SUMMARY OF QUANTITIES (Water main enclosure)

SUMMARY OF QUANTITIES (Gas Well enclosure)

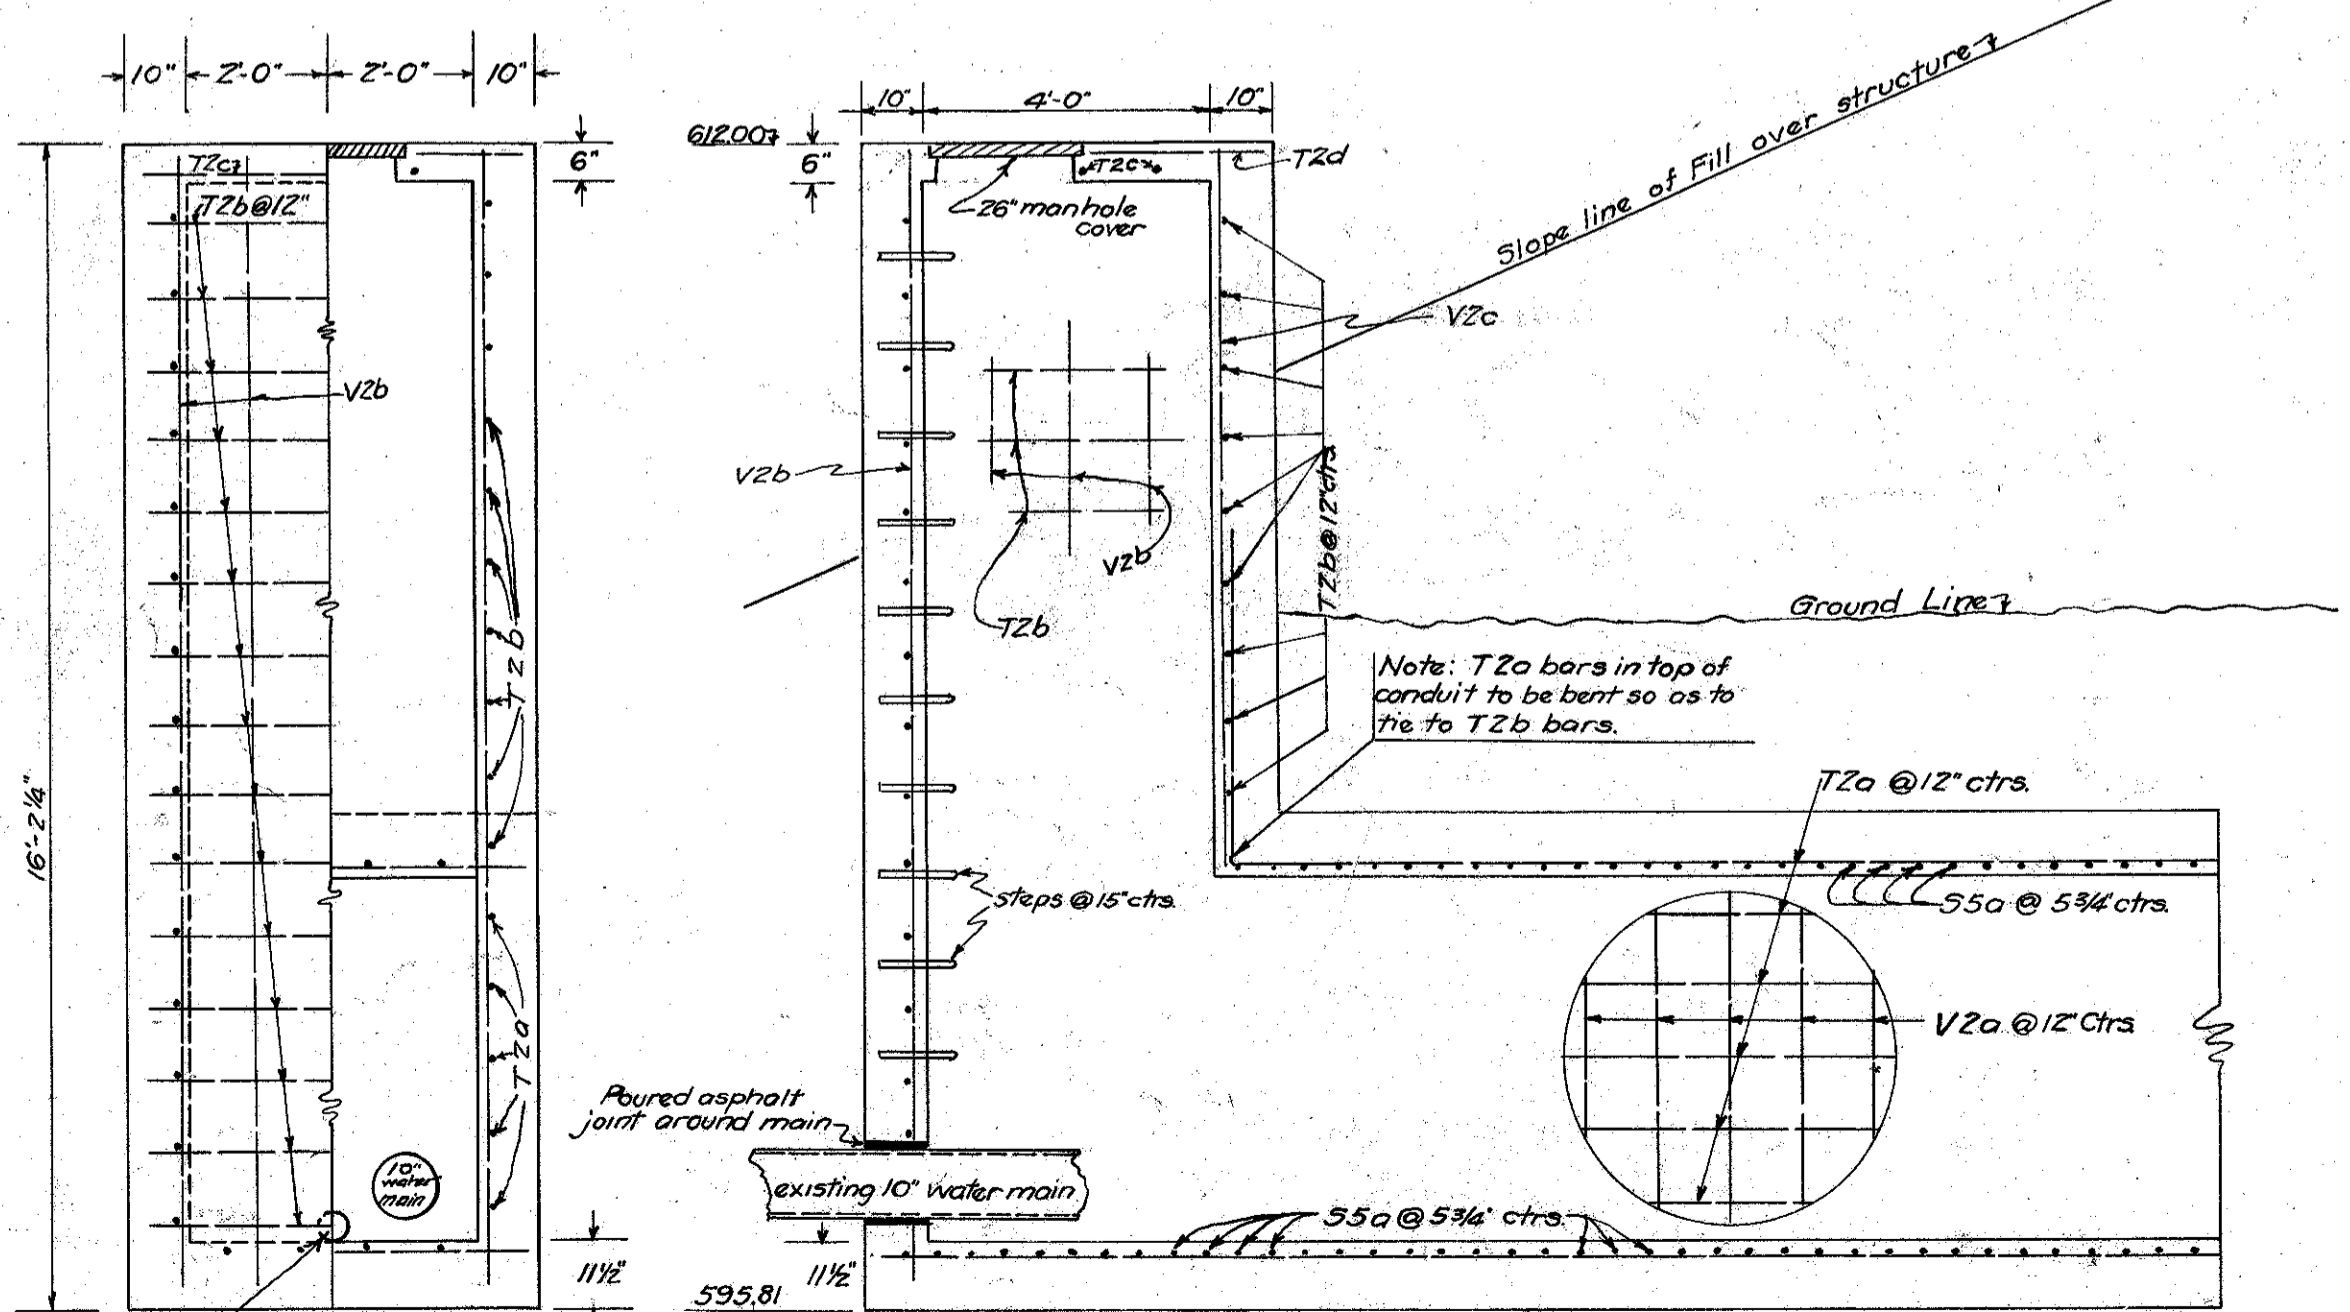
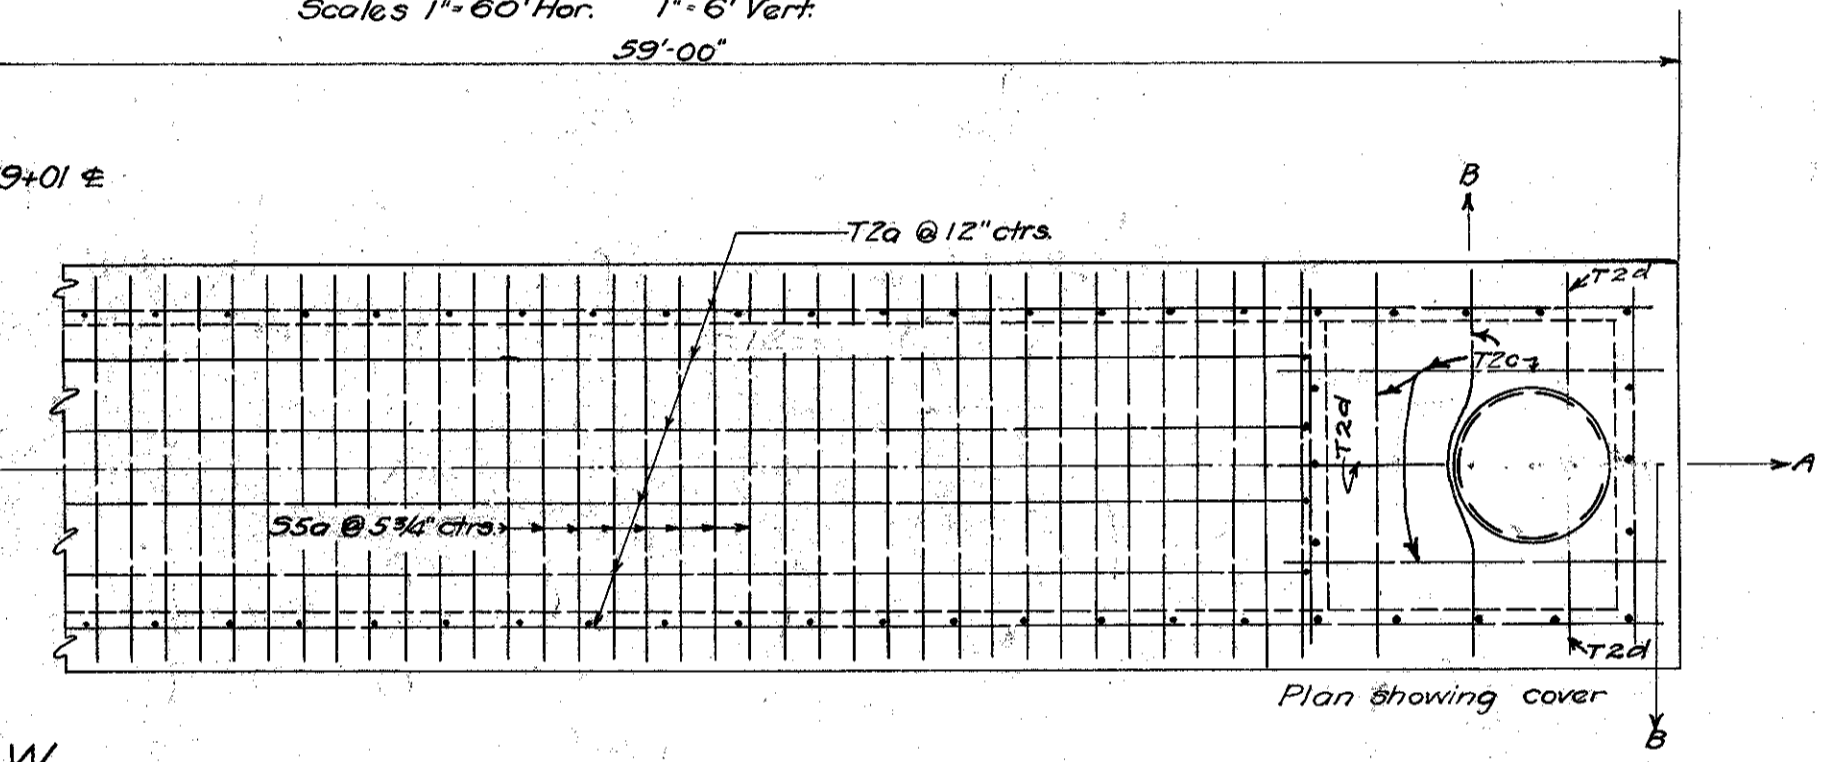
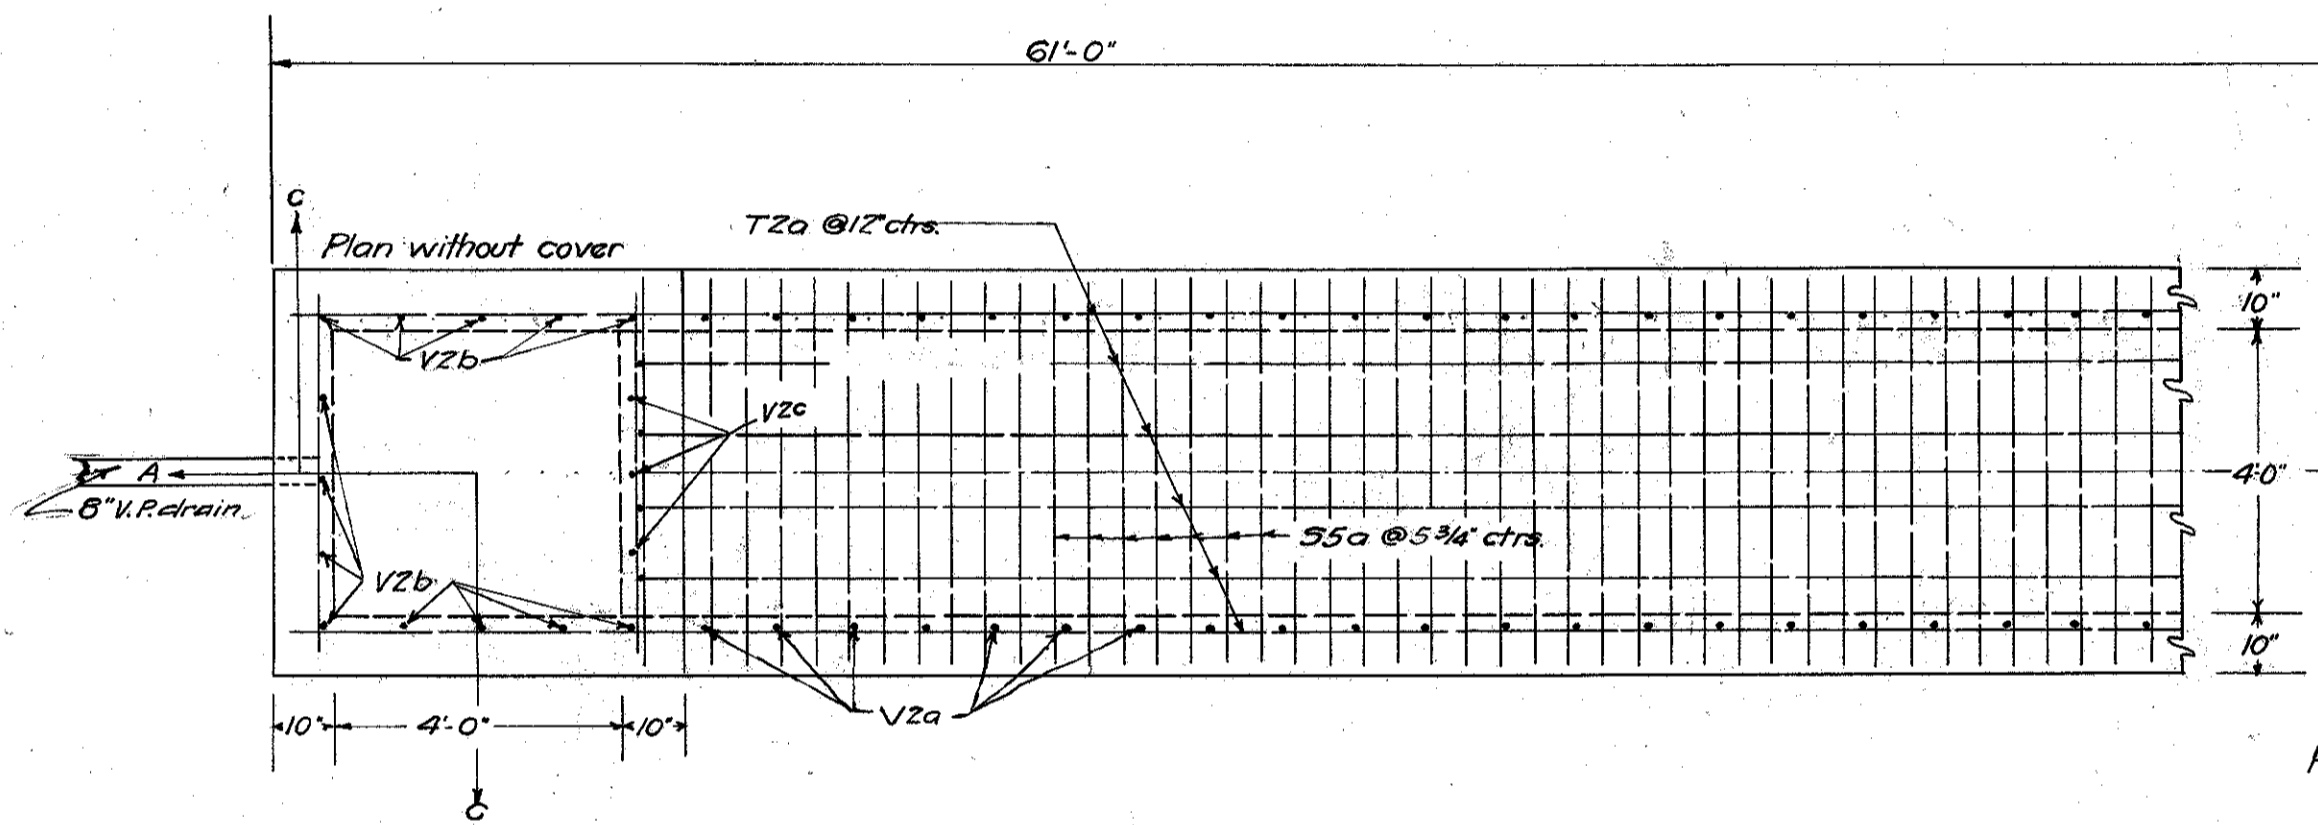
Approved. Date 4/13/31
 Board of Public Affairs Vill. of Willoughby
 By _____ Clerk,
 subject to the fulfillment of the conditions set forth in the letter of April 13, 1931, from George B. Gascoigne, Consulting Engineer, a copy of which is hereto attached.
 Geo. F. Law, Clerk.

Note: extreme care shall be taken in excavating around and backfilling over the 10" water main. Contractor shall keep main water-tight and in continuous operation, and leave it in good condition at the completion of the work.

Water main to be carried on concrete cradles 12" in width and spaced on 12" centers.

The conditions set forth in the above letter have been complied with. The necessary changes and notes covering same have been made part of this plan.
 A.B. Wilson
 Resident Engineer
